September 18, 2003

**RE: Source Holder for the Gammacell 3000 Packages
Registry of Radioactive Devices Number NR-0220-D-102-S**

**C-3000 - 2 POSITION
SOURCE HOLDER BODY
ASSEMBLY**

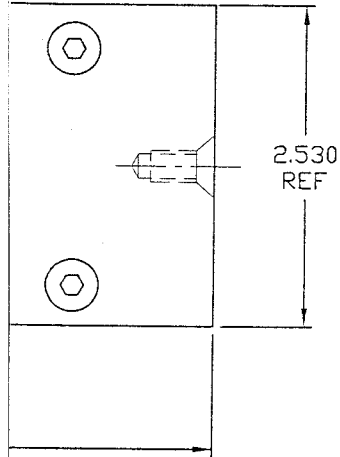
I am writing to request the addition of a new source holder design found on the attached drawing number C103203-213 and C103203-214 for use in the Gammacell 3000. Please note that the new source holder will be used, as an alternate to the existing source holder, which will continue on being used in the Gammacell 3000 depending on the customer needs. The new source holder for the Gammacell 3000 has been modified to improve the dose distribution inside the sample canister. The source holder is fixed inside the Gammacell 3000 in the same fashion as before.
